# Chair of Frodsham Town Council's response to Solar farm application.

This is a personal response from Helen Hayes, Chair of Frodsham Town Council. The Council will be officially responding to the Solar Farm application via the Frodsham Neighbourhood Plan group.

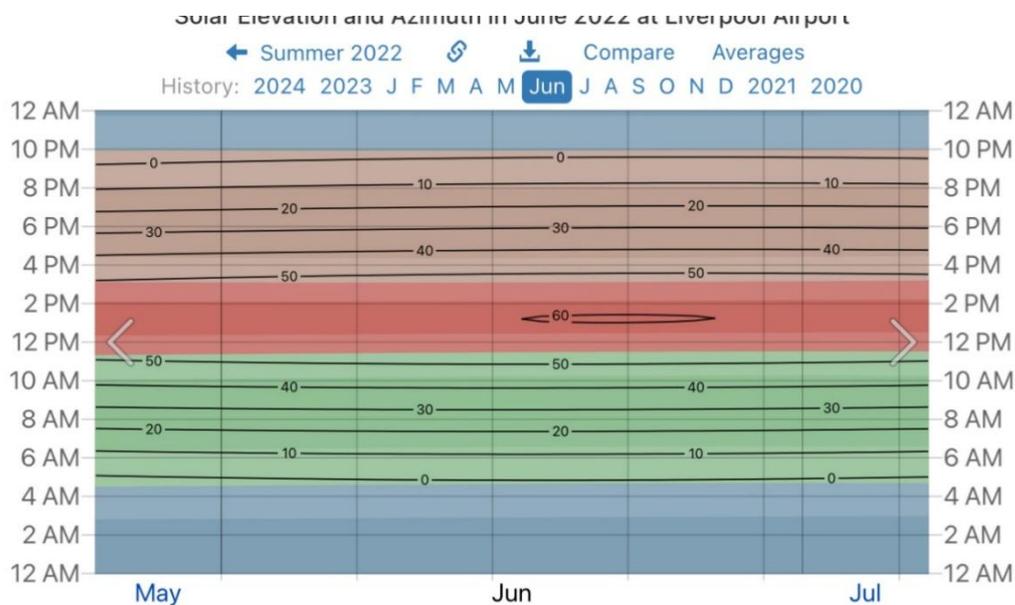
Examination of the power output curve shows that virtually no electricity was generated before 07:30 am. This is to be expected as the sun will be at low elevation and in the east, at right angles to the panels and will be approaching the panels at very low intensity. At about this time however power begins to be generated at an increasing rate as the sun moves both southwards and in front of the panels and its elevation increases. Comparison of this time with the published data for the sun's elevation (June 2022) at Liverpool airport shows it to be approx. 20° at 07:30.

Screening could be sited in front of solar panels, without significant loss of PV output, so long as they do not block out sunlight approaching the panels at an elevation of  $20^{\circ}$  or higher.

**Illustration of impact of 7m & 8m tree screens on sun's access to solar panels in mid-June.**

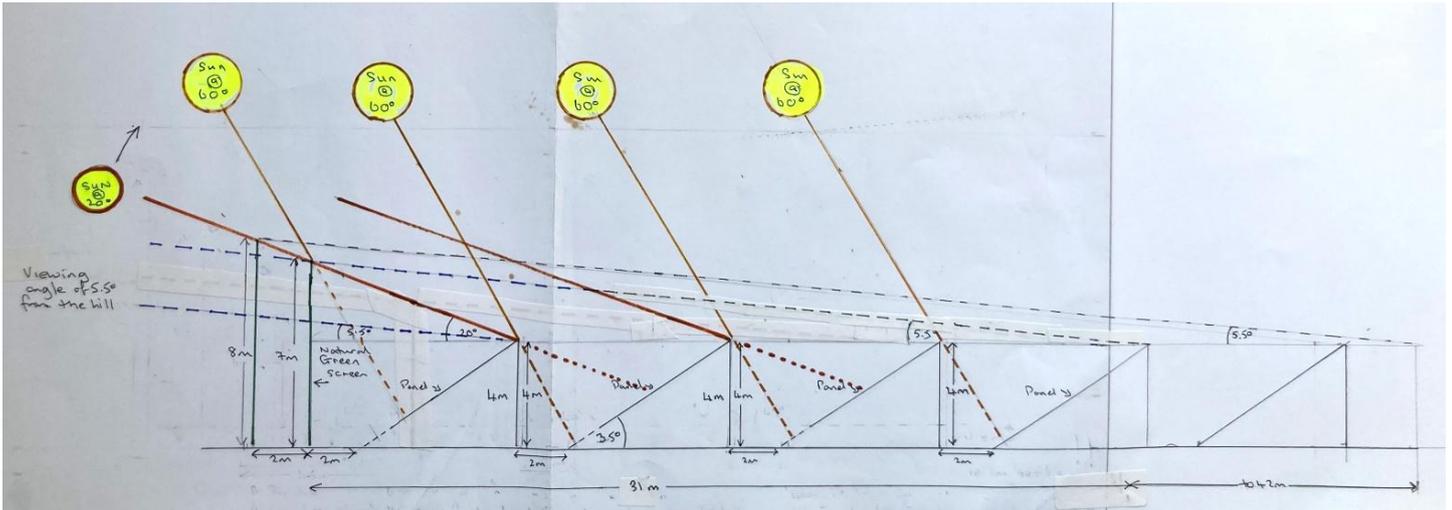
Recognising the importance of this to the community we reviewed Table 1 in the applicants [Design Parameters statement](#) and learned that the rows of panels are up to 4m high; can be as close as 2m and will be angled at between 10°– 35° to the horizontal. The scale drawing below illustrates this for the highest, most upright and closest configuration and shows the viewing angle from the top of Frodsham hill is 5.5°.

Evidence is available, with calculations, in Appendix 1, which shows that locally the sun barely generates any power at angles less than 20°. Even at this angle the drawing shows that a large area of all panels behind the front row will be screened by the panels in front of them. i.e. the applicant's design includes a high level of screening which would prevent power generation even when the sun is less than 20°.

Recognising this fact, placing a tree screen in front of each row, the top of which presented an angle of 20° to the front panel, would not affect the solar power generated for all but the front row. For illustration purposes, the diagram illustrates how 7 or 8m high screens can be as close as 2-4 m respectively, to the front row. As trees naturally have different sizes & shapes, suitably shaped trees would need to be placed in front of each block of arrays such that a 20° angle was maintained.

Importantly the illustration shows that, as the viewing angle from Frodsham hill is only 5.5° for the nearest array of panels, a row of 7-8m high trees would screen from view approx. 31-42 m of the panels behind the front row of panels. This screening benefit would increase to approx. 70-93m for the most distant panels and the extent of screening would be approximately doubled when viewed from Helsby hill.

Note 1: the trigonometry (Appendix 1) shows that for every 1m that a screen is above 4 m there is ten-fold increase in the screening benefits for the closest blocks of arrays.

1. Use of natural screens of trees, bushes and shrubs in front of each section of panels.
2. Varying the heights of the natural screens over a range of 7- 8m and also varying the distances from the front of the panels and the width of the screens.
3. Frequently softening the straight lines and edges of the rows of panels.
4. Leave open areas within the largest sections of panels and create small copses of trees and bushes.
